NOTICE TO ALL FIRMS

Re: Addendum Number 2 IFB # C1585R – Pomerantz New Fire Alarm System – Rebid

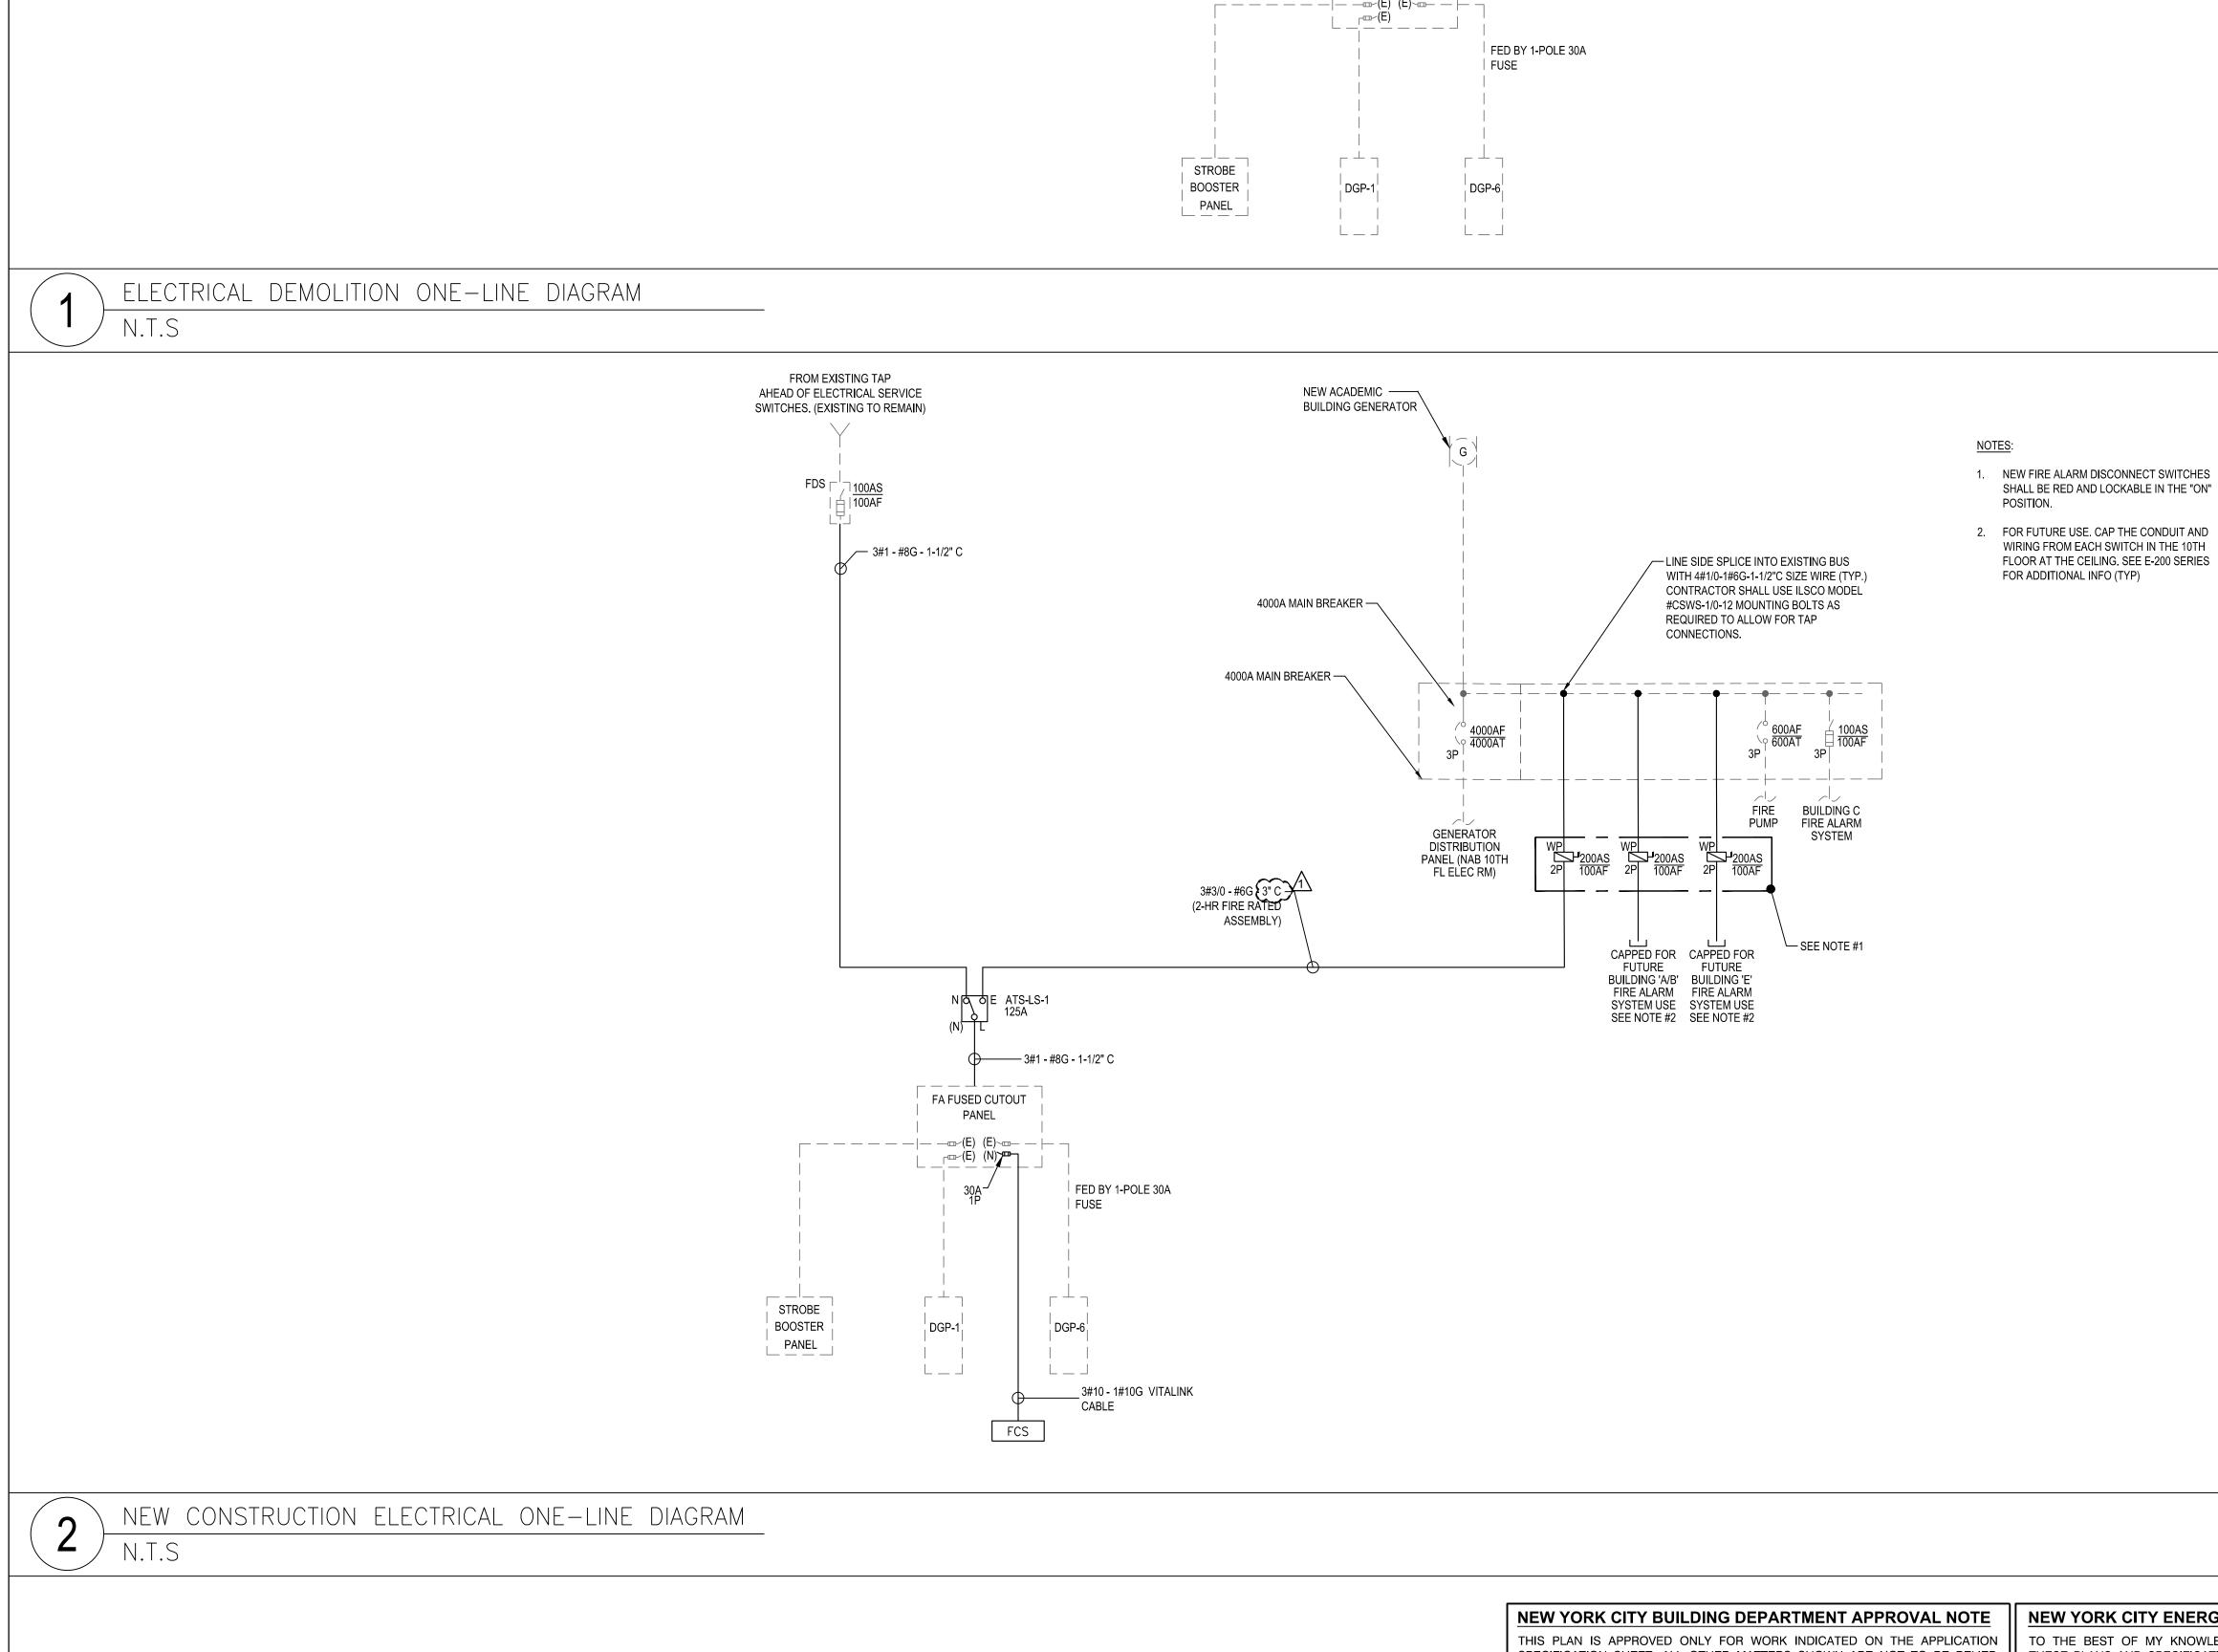
Q1. According to the specifications for the Duralife RHH cables, the attached charts shows the conduit fill which states 1-4 #3/0 conduits are to be in a 3°C, please note that the conduit size on drawing E-601 will not hold the Duralife conductors due to the insulation on the conductors, so the conduit size must increase. Please advise.

A1. A 3-inch EMT shall be used as suggested by the RFI. Refer to the updated drawing sheet E-601.00 (attached).
